# Historic Preservation Board

**April 13, 2016 at 9:00 a.m.**

**Staff Report  
April 13, 2016**

**COR 16-005** Request by Lien Pham on behalf of Pensco Trust Co. for a Certificate of Review for a two story addition at the residence at 407 Melrose Avenue. A variance is requested to allow a side setback of 7 feet in lieu of the required 20 feet to the lot line; with 25 feet to the street edge. A variance is requested to allow a floor area ratio of 39% in lieu of the allowed 38% Zoned R-1AA. Parcel ID. #07-22-30-8910-02-211.

2ND FLOOR PLAN - RENOVATION  
1/4" = 1'-0"

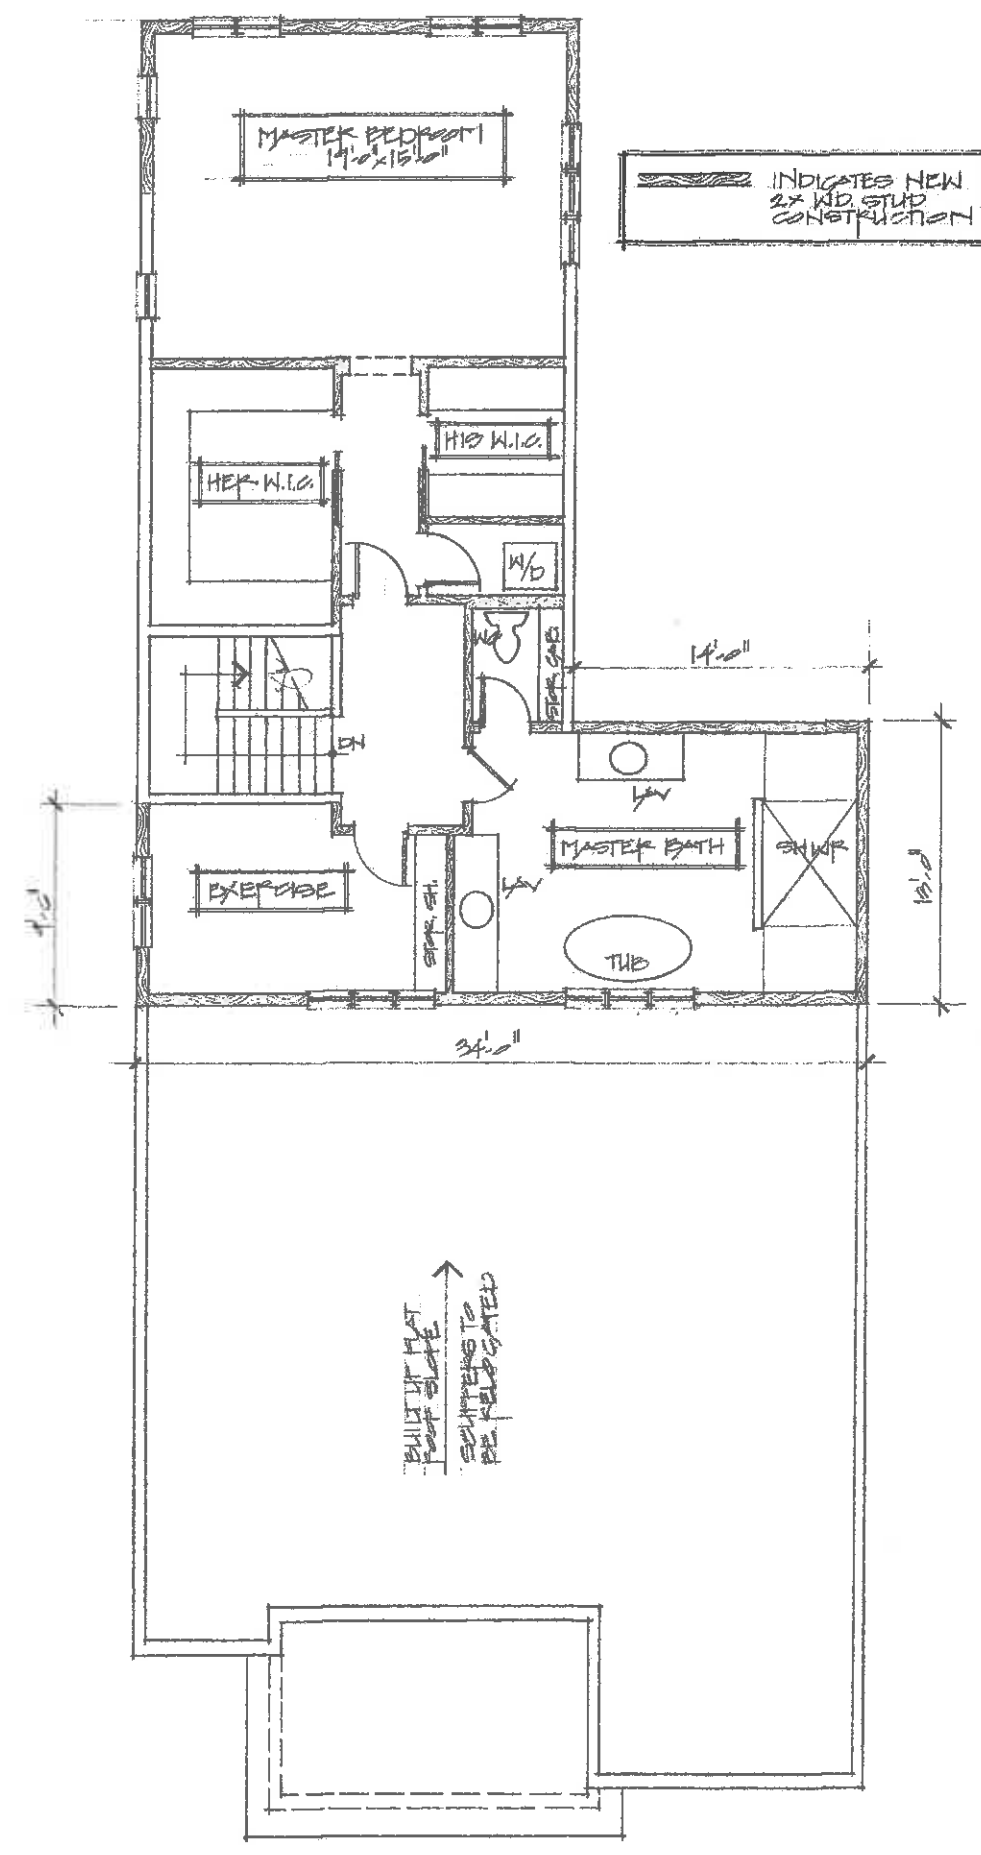
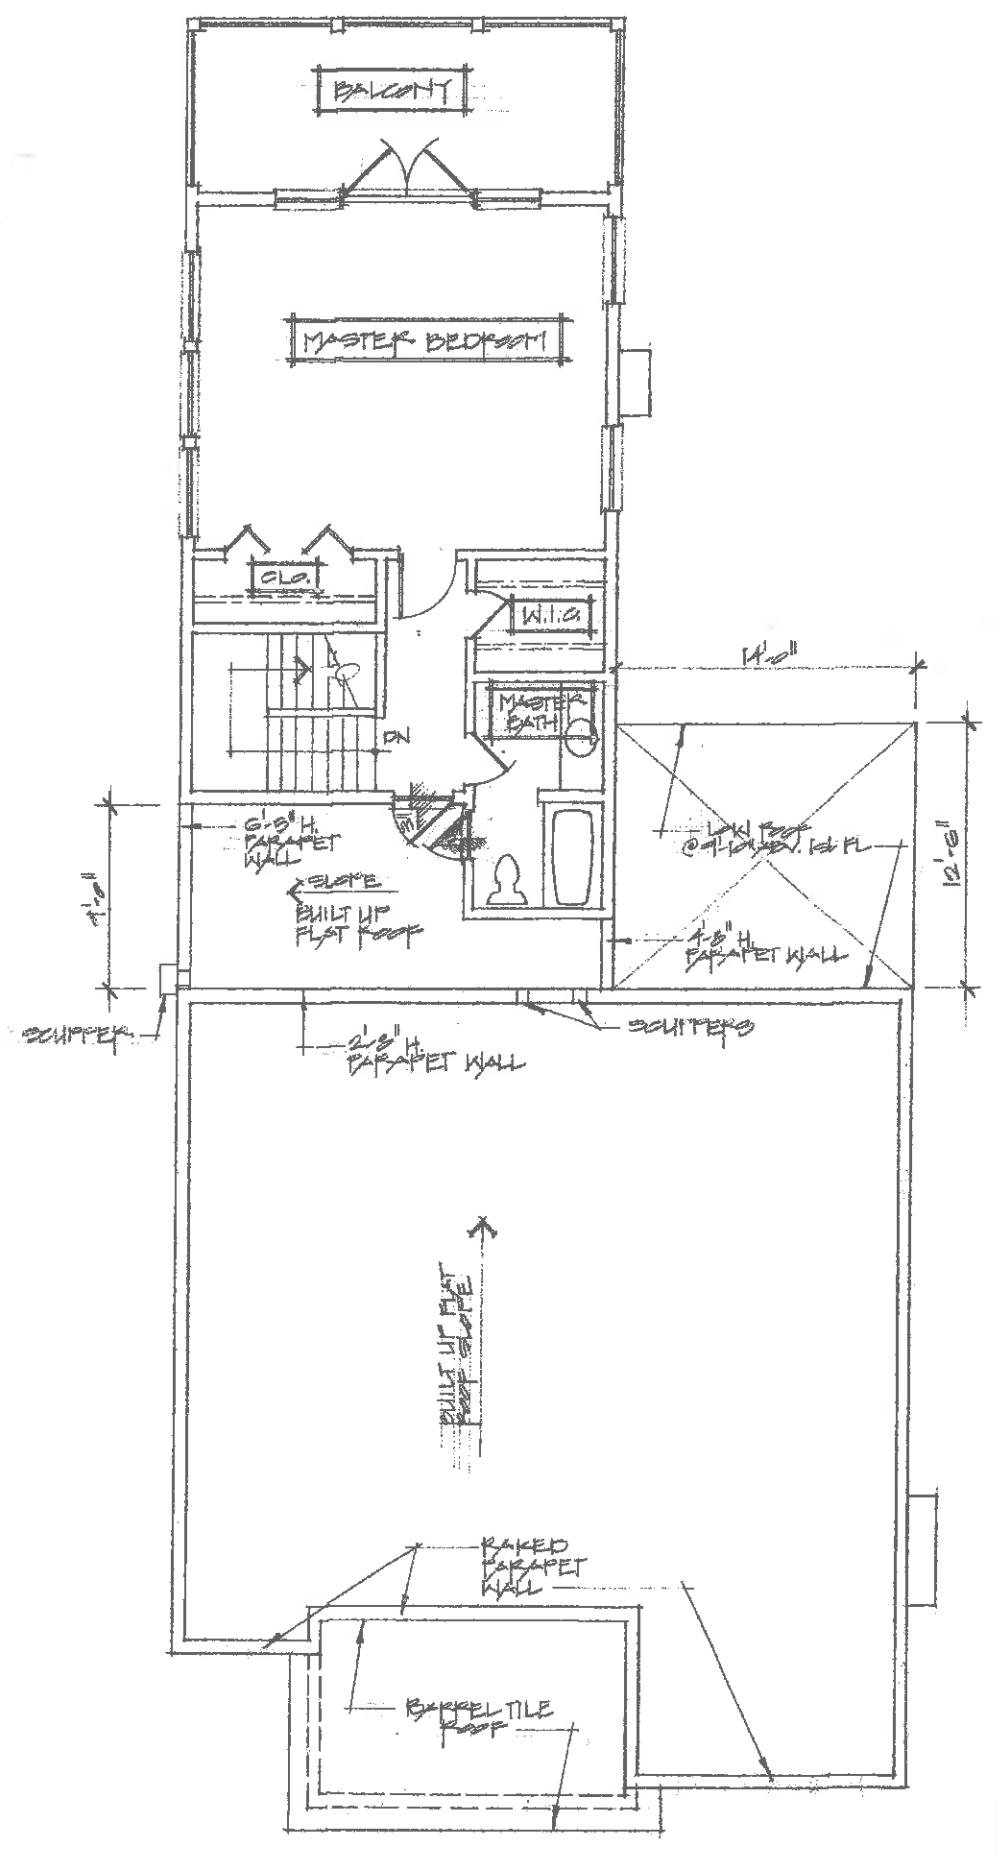
While the new second floor addition is forward of the existing second floor, it is still well recessed from the front of the house and differentiated from the historic façade. A significant visible change occurs at the northwest side elevation where the proposed addition goes up extends to the side elevation; adding a second story up from the existing one story area for a distance of 12.5 feet before ending and moving back to the existing side wall. A variance is requested for a second floor setback of 4.4 feet (the existing one story side setback) in lieu of the required ten foot side setback. This creates a second story "block" along this otherwise one story elevation that is visible from the street.

The abutting neighbor has raised an objection to this portion of the proposal and the variance request due to the proximity to the lot line and the visual impact (statement attached). A compromise was presented that staff recognizes as a solution to the 12.5 foot second story "block" of the addition on the northwest side. The recommendation is to recess the northwest side portion of the second floor addition back from the side wall plane by 3 feet with a tiled shed roof to make the transition from the second floor to the first. A variance to allow a 7.4 foot side setback to the second floor in lieu of the required ten feet would still be needed. The addition's massing would be improved and the neighbor would have less visual imposition from the addition. A tiled shed roof would be compatible with the architecture.

2. Approve the second floor addition with the condition that the northwest side wall of the second floor be recessed 3 feet from the first floor side wall plane with a tiled shed roof transition; granting a variance to allow a 7.4 foot side setback to the second floor addition.

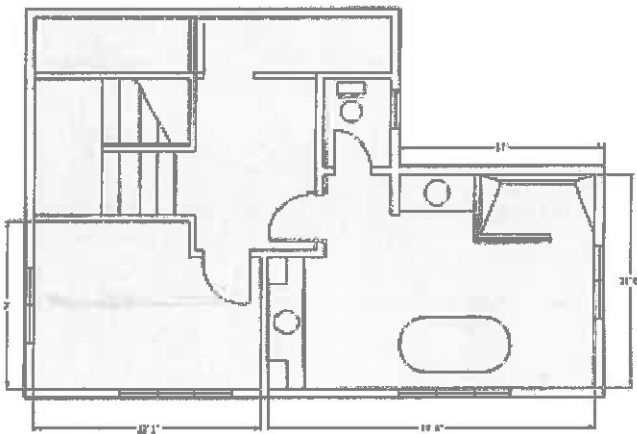
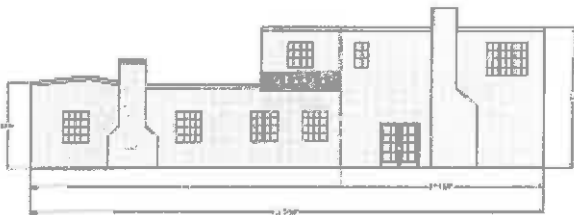
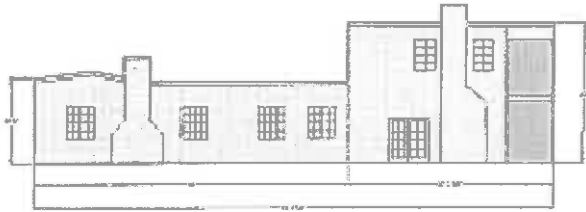
To extend this unfortunate disconnect in architecture by placing a vertical wall a mere 4'5" from our property line in lieu of 10.0' would be imposing, unfortunate, and unfair to me and my family. This wall, as represented on the plans, would extend over 20' straight up, additional square footage for sure but doing nothing to soften the abrupt transition from the charming front facade to the boxy addition.

I think the following represents a reasonable solution. This is so close to the property line that I believe it would require a fire rated wall.

**Symmetry:** I understand the desire for the second floor front elevation to align with the wall on the right, albeit 49' back from the front plane and not so noticeable. It's appropriate to note that symmetry isn't an established characteristic on the home, nor should it be. The first floor architecture is beautiful, and asymmetric.

**Side set back:** In lieu of the 4'5" side setback proposed on the second floor or the required 10'0" setback one could do the following. If the addition were pulled back just three feet then a small tile roof, matching the front of the home, would break up the excessive plane and provide some open space, minimizing the "canyon" effect. This would result in a second floor side setback of 7'5" in lieu of 10'0", still a sizable variance but acceptable for us.
